Safety Evaluation Report
for the
Application for Contents Amendment for Shipping
Isentropic Compression Experiment (ICE) Apparatus
in 9977 Packaging
Revision 2
February 20, 2009

Docket Number 09-05-9977

March 2009

Figure 4-3 ICE Configuration in the 9977 (6CV)

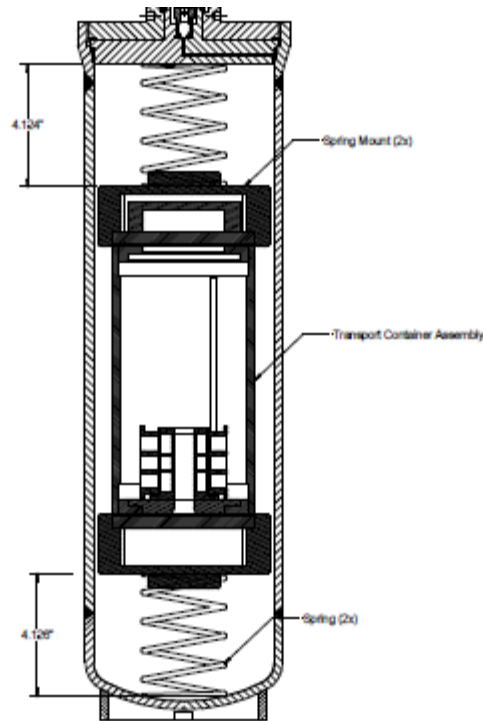
The ICE apparatus consists of a stainless steel assembly containing about 8 grams of ²³⁹Pu or its dose equivalent as noted in Table 1, *Comparison of 9977 Content C.1 and the ICE Radioactive Contents*, of the Submittal. The ICE target is mounted on the transport container assembly base. A Viton[®] O-ring seals the transport container base to the transport container body. Another Viton[®] O-ring seals the transport container handle to the transport container body. The ICE apparatus weighs less than 30 pounds^[5] and has less than 0.6 watts decay heat rate. For the Model 9977 Package, the maximum payload weight is 100 pounds and the maximum decay heat rate is 19 watts.^[2] Thus, the maximum payload weight and the maximum decay heat rate for the Model 9977 Package easily bound those for the ICE apparatus. Figure 4-3, *ICE Configuration in the 9977 (6CV)*, and Figure 4-4, *Required Foam Within Coil Springs (Top Shown, Bottom Similar)*, are reproduced from the document, *9977 Containment Vessel Dynamic Response with ICE Payloads*.^[5] The Figures show the packaging system, consisting of two spring mounts (6061-T6 aluminum), two springs formed from American Society for Testing and Materials (ASTM) A 288 QQW-470 steel music wire, and two square blocks of foam (Last-A-Foam[®] TF-5070-10 or equivalent) retained within the springs. The springs and blocks alone do not provide adequate damping for vibrations, arising from transportation, and the addition of foam energy-absorbing materials is necessary.

Figure 4-4 Required Foam Within Coil Springs (Top Shown, Bottom Similar)

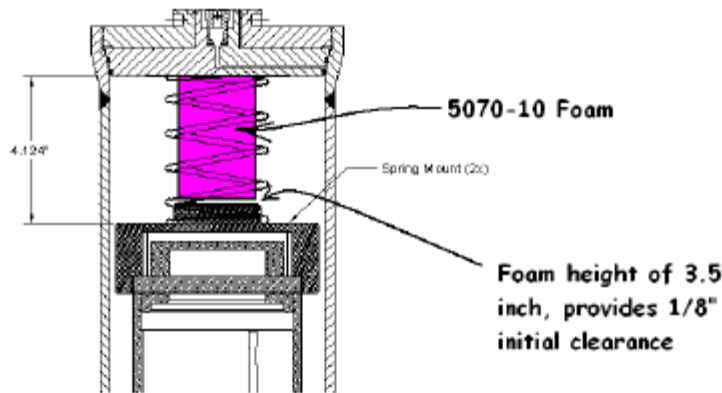
The ICE assembly requires a set of spring mounts, a set of springs, and a set of square blocks of foam, retained within the springs, in order to achieve adequate damping of vibrations during transportation in the 6CV for the Model 9977 Package.^[5] However, the ICE assembly has to be an approved content configuration per Section 7.1.1.2, *Contents/Payload Preparation*, of the Model 9977 Package SARP in order to be loaded into that Packaging, so, there are no changes to Chapter 7 of the Model 9977 SARP.
